Product Change Notice (PCN)

PCN Number: **PCN-0456191R-01**

Product(s) Affected: **PJ-042H**

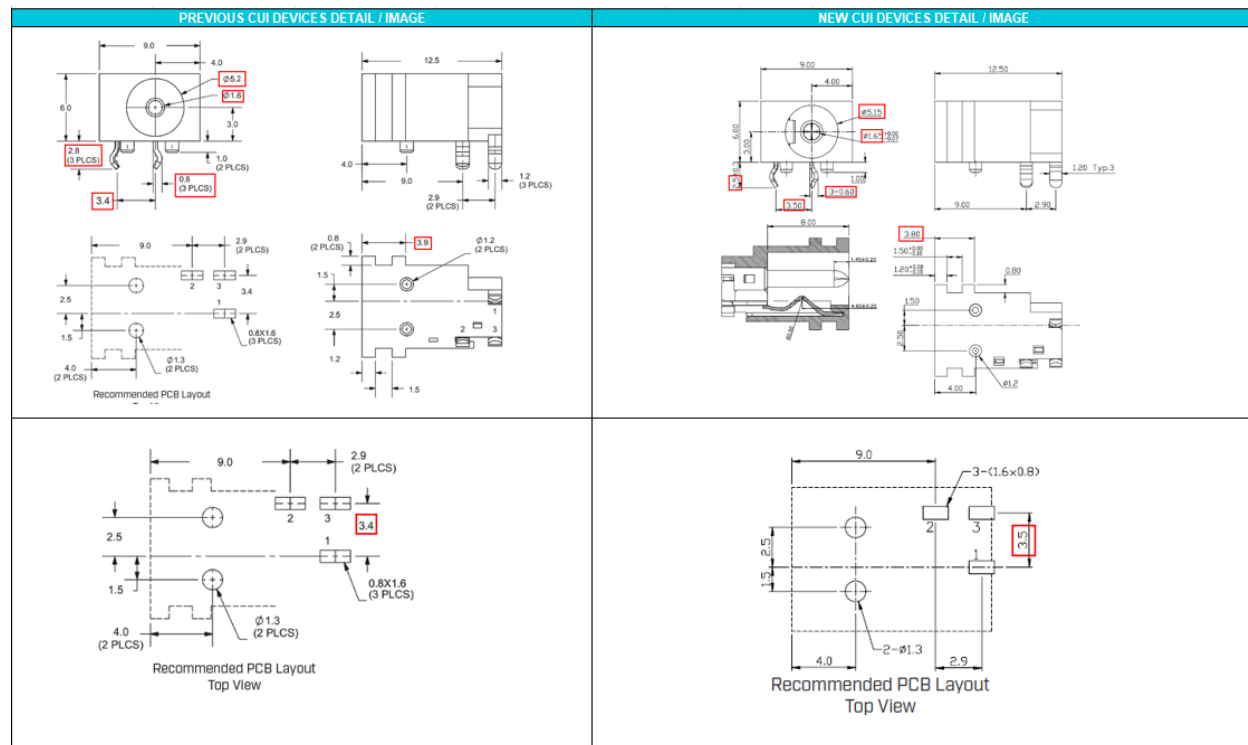
Description of Change: **New Factory Location. Product re-engineered for improved manufacturability and production yield. See image below for reference and check CUI Devices website for updated drawing. Cosmetic differences may be visible and not affect the form fit and function of the product.**

PREVIOUS CUI DEVICES DETAIL / IMAGE			NEW CUI DEVICES DETAIL / IMAGE		
DESCRIPTION	MATERIAL	PLATING/COLOR	DESCRIPTION	MATERIAL	PLATING/COLOR
center pin	brass	tin	center pin	bronze	tin
terminal 1	brass	tin	terminal 1	bronze t=0.35	tin
terminal 2	phosphor bronze t=0.3	tin	terminal 2	B2-Cu t=0.30	tin
terminal 3	brass t=0.3	tin	terminal 3	brass t=0.40	tin
housing	PAB6 (UL94V-0)	black	housing	PAB6-30%GF (UL94V-0)	black
MATING PLUG Jack Insertion Depth: 7.8 mm			MATING PLUG Jack Insertion Depth: 8.0 mm
